OCONEE NUCLEAR STATION UNIT 1

FEEDWATER SYSTEM

(STEAM GENERATOR DRAIN & RECIRCULATION SYSTEM)

REQUEST FOR RELIEF #93-03 sht. 2 of 2

DWG. NO. OFD-12181.5

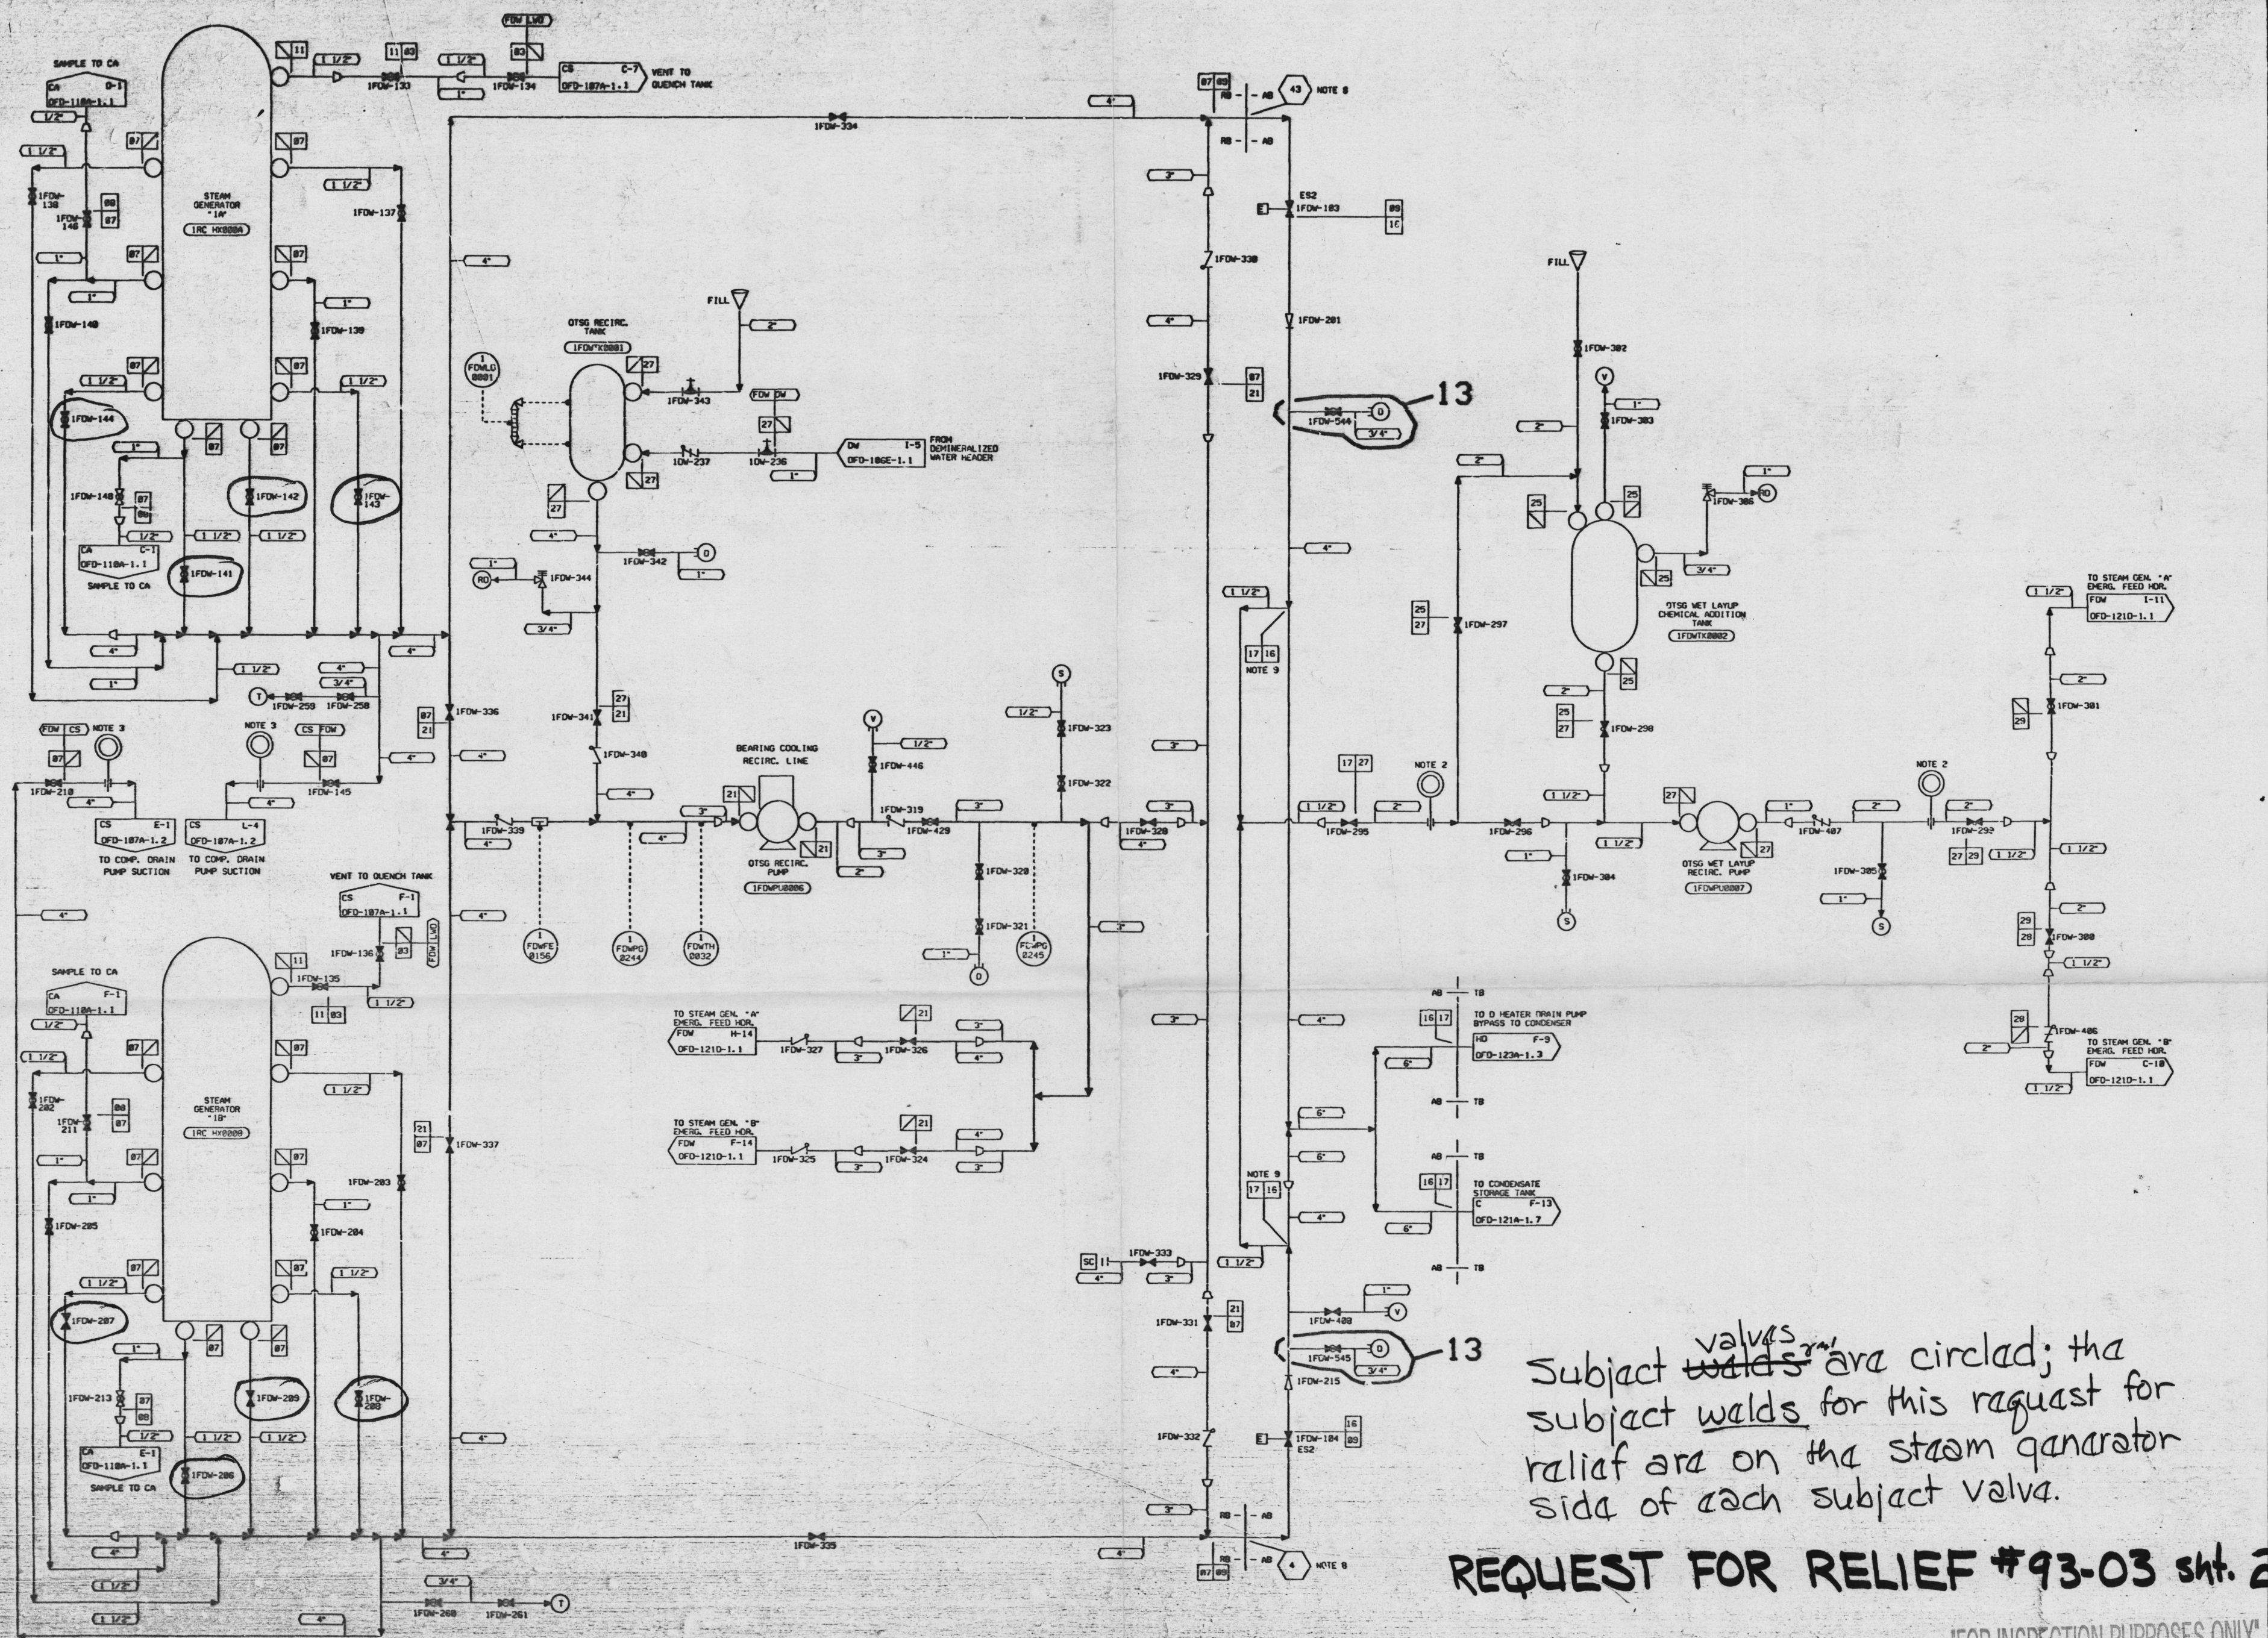
Subject ~~welds~~ valves are circled; the subject welds for this request for relief are on the steam generator side of each subject valve.
